Product Change Notification / JAON-17NPXF486

CCB 3280.003 Final Notice: Qualification of MTAI as new final test site for selected AT24C0xx, AT24C16x, AT24C32E, AT24C64B, AT24HC0xx, AT93C46x, and AT93C86A device families available in 8L PDIP package.

CCB 3280.003
Pre and Post Change Summary
PCN# JAON-17NPXF486

Pre and Post Change Summary - Pin 1 Orientation

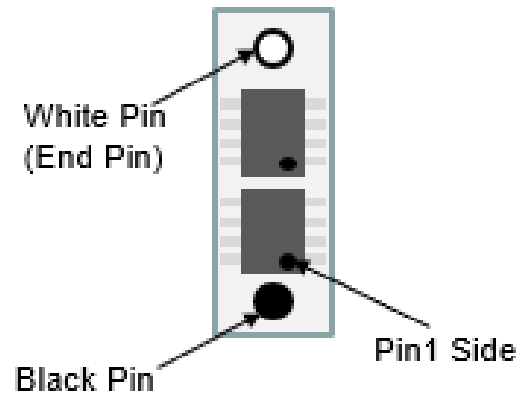
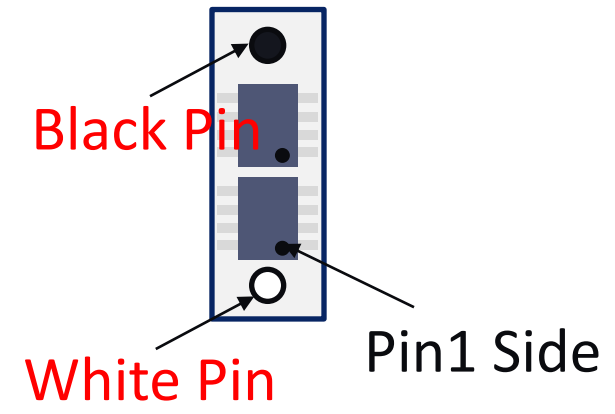
Description of Change:Qualification of MTAI as new final test site for selected AT24C0xx, AT24C16x, AT24C32E, AT24C64B, AT24HC0xx, AT93C46x, and AT93C86A device families available in 8L PDIP package.

Pre and Post Change Summary – Tube Drawing

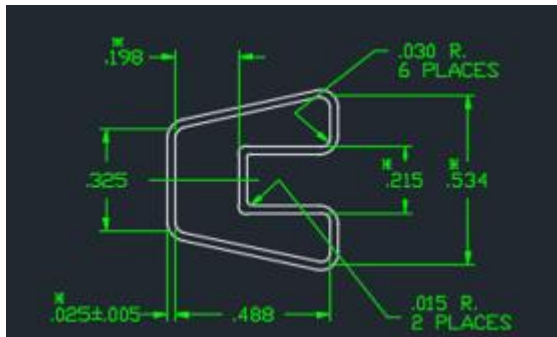
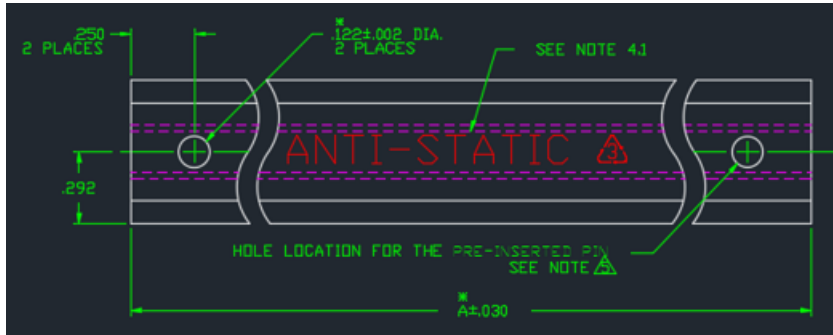
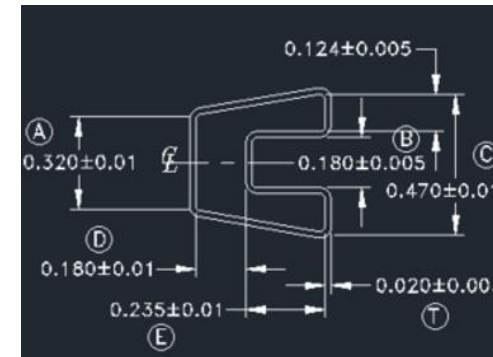
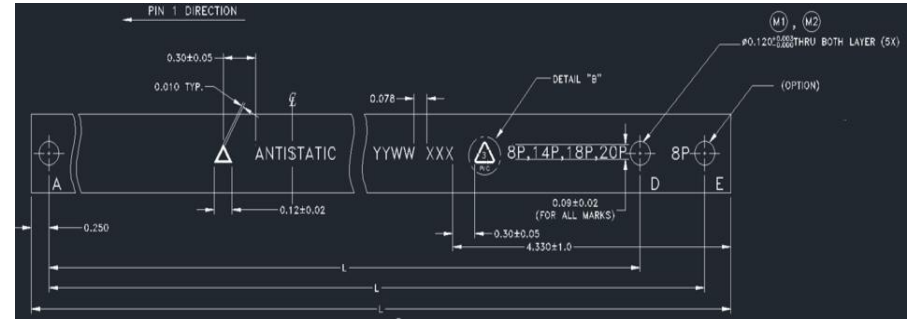
Plant	Tube Length (inch)	Center Hole A to Center Hole D (inch)	A (inch)	B (inch)	C (inch)	D (inch)	E (inch)	T (inch)	Color
ANAP	20.00 +/-0.030	19.50 +/- 0.030	0.325 +/- 0.010	0.215 +/-0.010	0.534 +/- 0.010	0.198 +/- 0.010	0.290 +/- 0.010	0.025 +/- 0.005	Transparent Clear
MTAI	20.33 +/-0.025	19.28 +/- 0.050	0.320 +/-0.010	0.180 +/-0.005	0.470 +/-0.010	0.180 +/-0.010	0.235 +/-0.010	0.020 +/-0.003	Transparent Clear
